Docket No. STN 50-447

AMENDMENT NO. 8 TO APPLICATION
FOR REVIEW OF 238 NUCLEAR ISLAND GENERAL ELECTRIC
STANDARD SAFETY ANALYSIS REPORT (GESSAR II)

Amendment No. 8 further amends GESSAR II by furnishing responses to the following questions requested by Enclosure 1 to the Commission's GESSAR II acceptance review letter dated December 3, 1981:

Figure 3.8-88. Foundation Outlines in Reactor Island

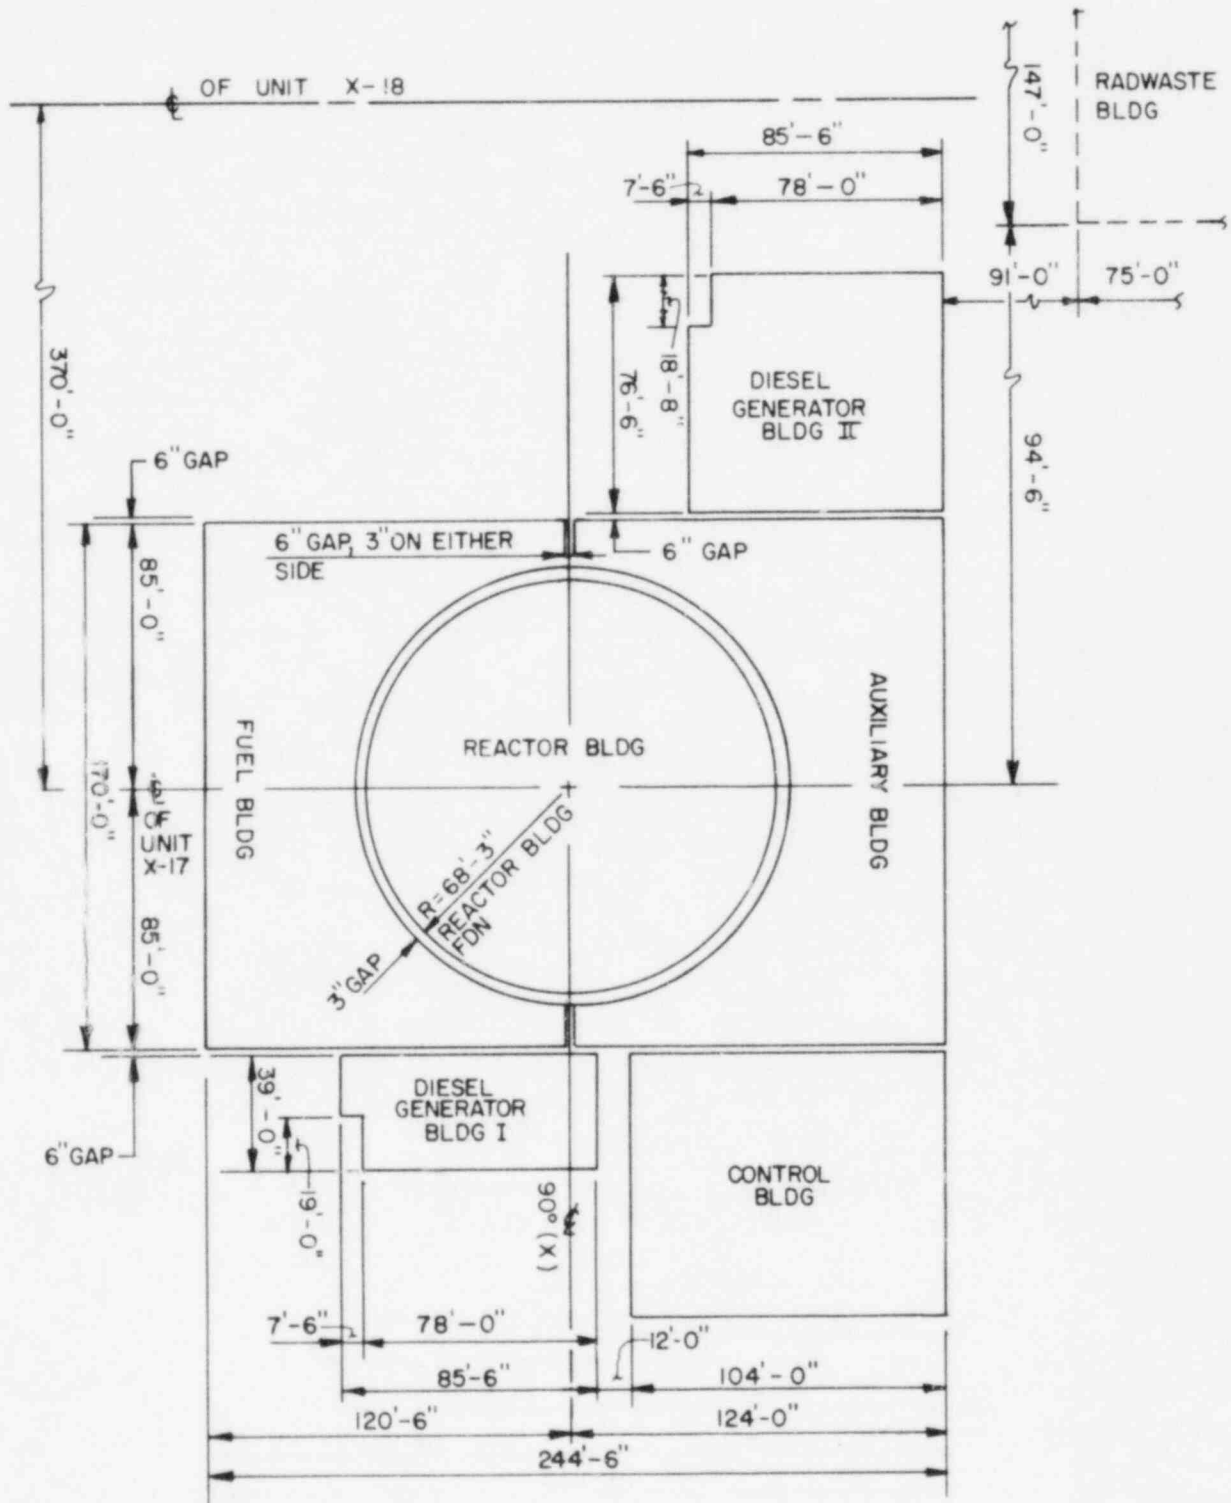
Describe how the ultimate and residual soil settlements were calculated, and discuss the applicability of these computations to a range of site conditions. Provide the required orientation, location and purpose of settlement points on Figure 3.8-91. Explain how settlement values will be interpreted, and establish limiting criteria. (3.8.6.2)

The ultimate and residual soil settlements and soil settlement profile are given in Table 3.8-11. Refer to Figure 3.8-88 for orientation and location of points.

Response to this question is provided in Subsection 3.8.6.2.
(Note: Figure 3.8-91 of the pre-docket version of GESSAR II is Figure 3.8-88 in the docket version.)
